SYSTEM/MODEL: AP-M

MODIFICATION: Increase receive volume at master station

INCREASE RECEIVE VOLUME AT AP-M MASTER STATION

AP-10M Schematic Diagram

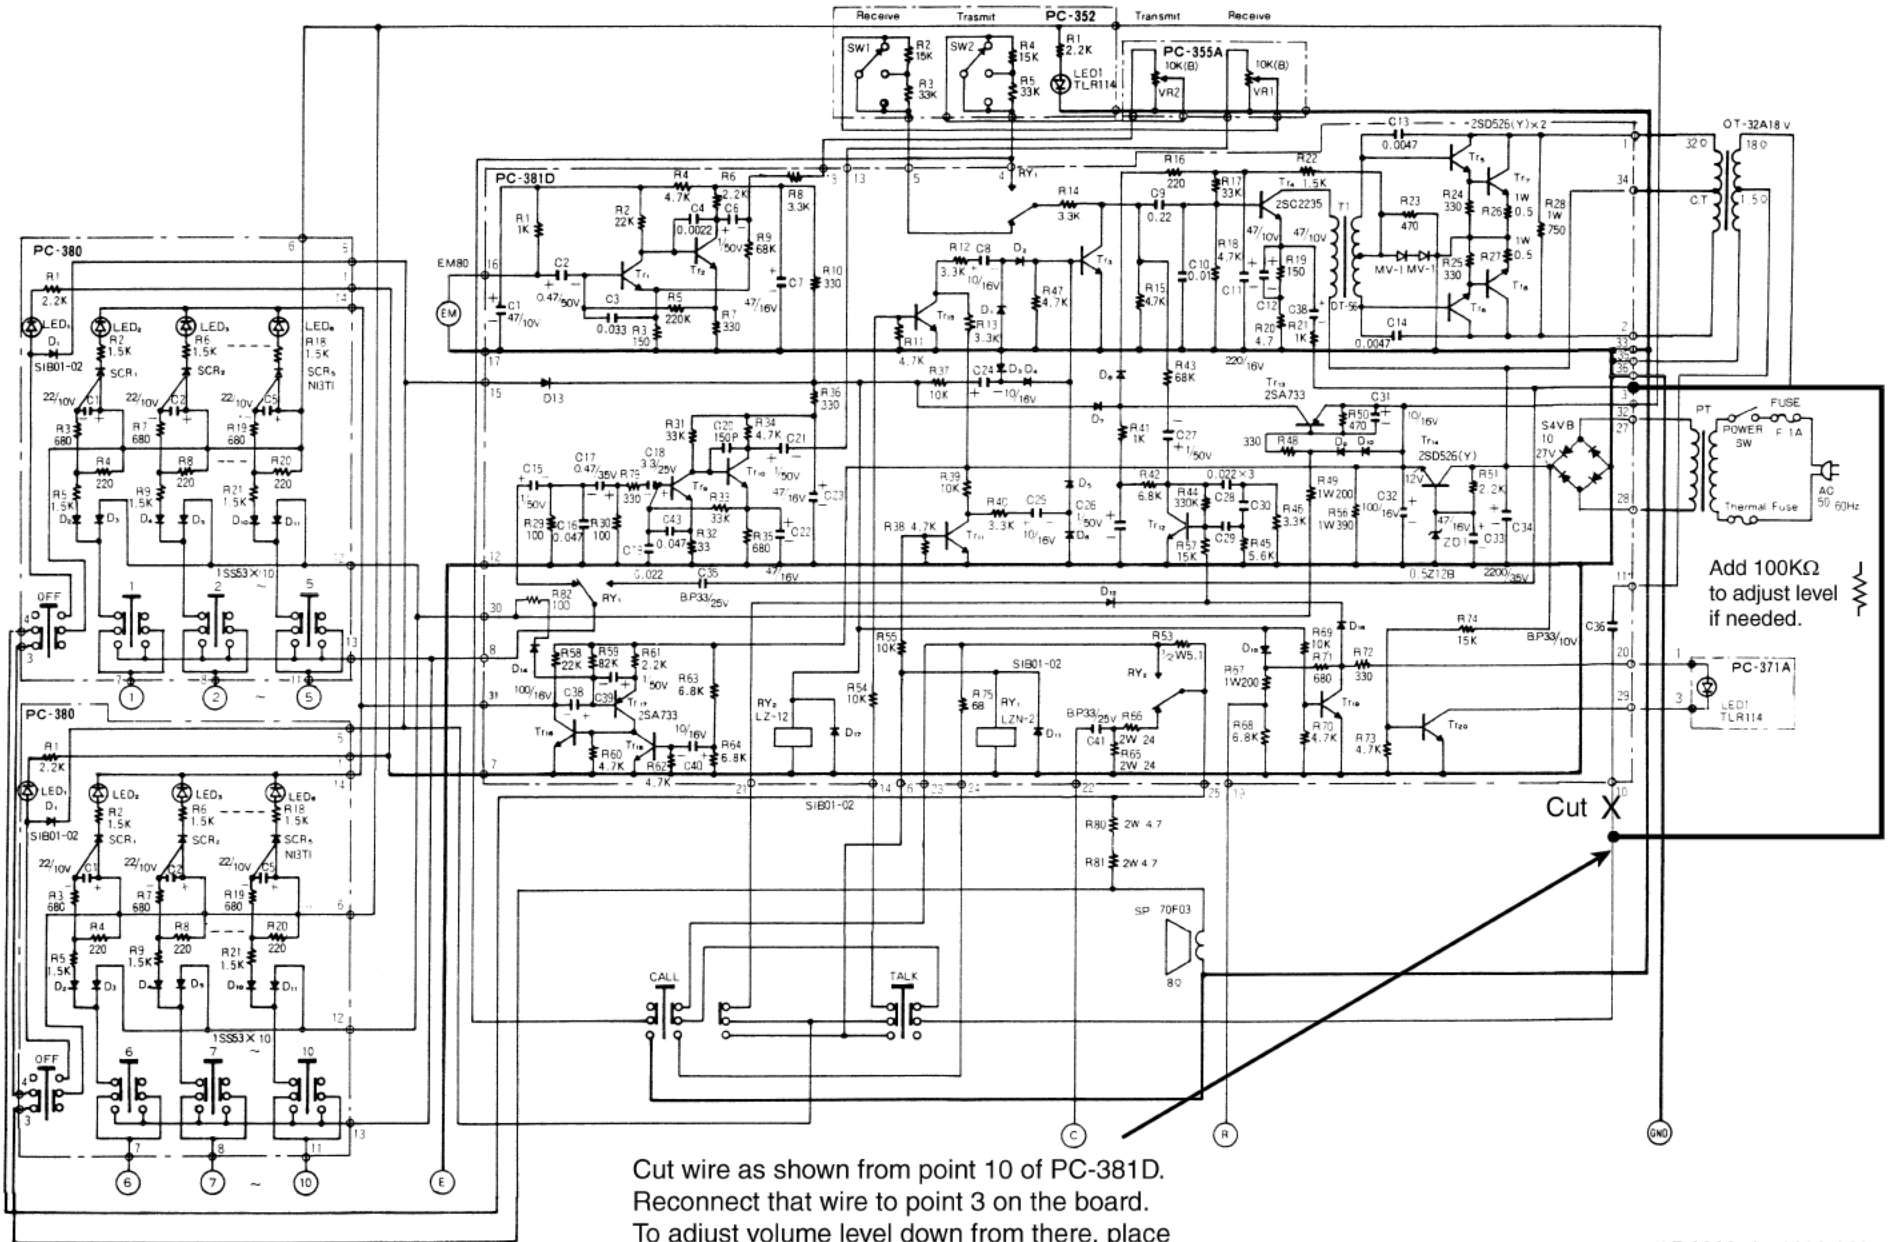
Cut wire as shown from point 10 of PC-381D.
 Reconnect that wire to point 3 on the board.
 To adjust volume level down from there, place
 a 100KΩ, 2W resistor in series with wire to point 3.

- INSTR/OPERATIONS**
1. Cut wire from point 10 of PC-381D.
 2. Reconnect wire to point 3 of PC-381D.
 3. If volume level needs to be adjusted downward after performing the above modification, place a 200K ohm, 2W resistor in series with the wire going to point 3.
